Columbia Generating Station NPDES Groundwater Study Review

April 2009
Publication no. 09-10-064

by
Laurie Morgan
Hydrogeologist, L.G., L.Hg.

Figure 1: Approximate monitoring well locations and discharge sites outfall 002 and outfall 003.

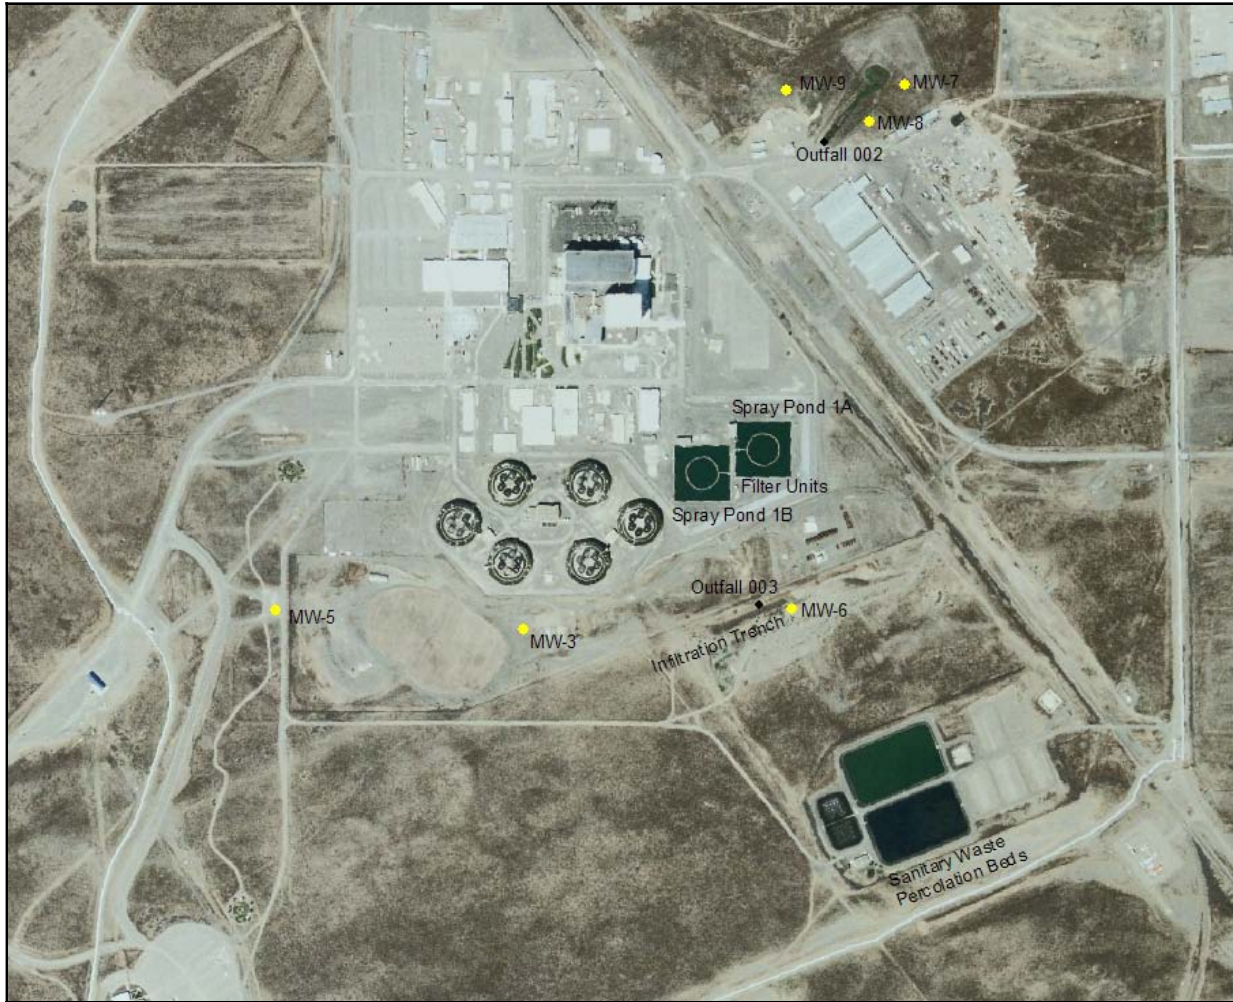
MW-9 is proposed as the upgradient well. MW-9 has been potentially influenced by discharge of water from testing the fire-protection pumps. According to the Battelle report, elevated concentrations of calcium, chloride, magnesium, sodium, sulfate, and specific conductance could possibly be from flushing of the salts from the desert soils. The Battelle report recommends continuing to use MW-9 as the upgradient well and continue to monitor since the levels for the above parameters are below regulatory levels.

Based on information provided in the Battelle report, it appears very reasonable to use MW-9 as the upgradient well with continued monitoring.

The Battelle evaluation concludes that MW-7 and MW-8 remain valid well locations for monitoring discharges from Outfall 002. The MEMO model requires site specific input, parameter estimates and interpretation. Since these elements were not provided as part of the submittal, I am unable to comment on the use of the model. Based on review of the hydrogeologic characterization, the conclusion that MW-7 and MW-8 are valid well locations appears to be reasonable.

Monitoring Well MW-3 is upgradient of Outfall 003 but downgradient of the closed RCRA landfill. Monitoring Well MW-5 is a better choice for the upgradient well since establishment of background ground water quality must be uninfluenced by site activities according to the Guidance. I agree with the QAPP that MW-3 is useful to monitor, both because it is downgradient of the landfill and upgradient of Outfall 003, and as noted in the QAPP, may help differentiate potential impacts from the cooling tower operations and discharges to Outfall 003.
